Access Compliance Report

Public Rights-of-Way

Intersection ID: 53380	Main Street: IKEA_BV	Cross Street: LEWIS_ST	Location: E
ADA ID: 2393D516C892	Ramp Type: BlendTrans1	Initial Pass/Fail: Pass	Overall Compliance: No
		Severity Score: 0

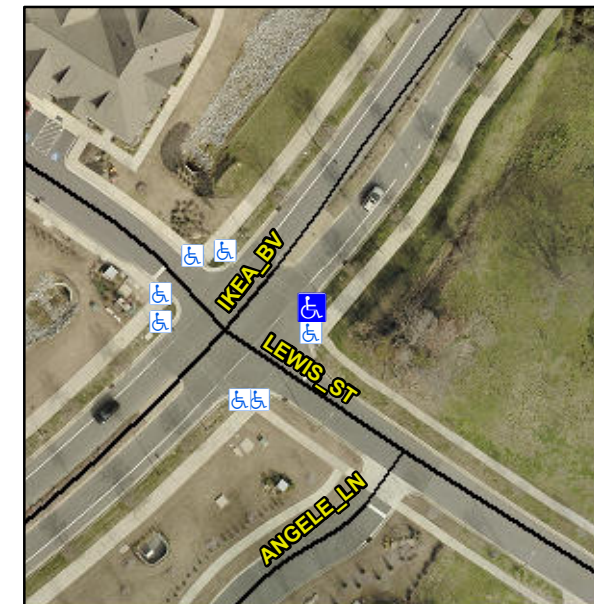
Not Found, R305.2, R302.7

Compliance	Description	Data	Compliance	Description	Data
N/A	Ramp Length (in)	52.0	Yes	BlendTrans Slope (%)	1.4
Yes	Ramp Width (in)	60.0	Yes	BlendTrans XSlope (%)	1.1
Yes	Flare Type L	Curbed_NoWalkSurface	Yes	Flare Type R	Curbed_NoWalkSurface
N/A	Flare Slope LT (%)	N/A	N/A	Flare Slope RT (%)	N/A
N/A	Flare Traversable LT?	No	N/A	Flare Traversable RT?	No
Yes	Landing Length (in)	101.0	Yes	DWS Provided?	Yes
Yes	Landing Width (in)	60.0	Yes	DWS Contrast?	Yes
Yes	Landing Slope (%)	1.1	Yes	DWS Length (in)	24.0
Yes	Landing X Slope (%)	0.0	Yes	DWS Full Width?	Yes
N/A	Landing Curb? (Y/N)	No	No	DWS Offset (in)	3.3
N/A	Shared Landing?	Yes			
No	Gutter Ponding?	Yes	Yes	Gutter Slope (%)	4.2
Yes	Gutter Lip Ht (in)	0.0	Yes	Gutter X Slope (%)	1.3
N/A	Painted X Walk1?	Yes	N/A	Painted X Walk2?	N/A
	X Walk 1 Direction	To NW		X Walk 2 Direction	N/A
	X Walk 1 Width (in)	60.0		X Walk 2 Width (in)	N/A
	X Walk 1 Slope (%)	3.8		X Walk 2 Slope (%)	N/A

X Walk 1 X Slope (%)	0.8		X Walk 2 X Slope (%)	N/A
Yes	Ramp inside XWalk1?	Yes	N/A	Ramp inside XWalk2?	N/A
	Road Slope (%)	0.8		Clear Space?	Yes
	Road X Slope (%)	3.8	N/A	Clear Space to XWalk (in)	N/A
Yes	Any Obstructions?	No	Yes	Storm Grate/Utility Hazard?	No
	Obstruction Type			Storm Grate/Utility Type	
		N/A			N/A
			Yes	Surface Condition? (G/P)	Good
			No	Curb Slope (%)	10.0

Remove & Replace Curb Ramp With Two New Directional Ramps or Equivalent.
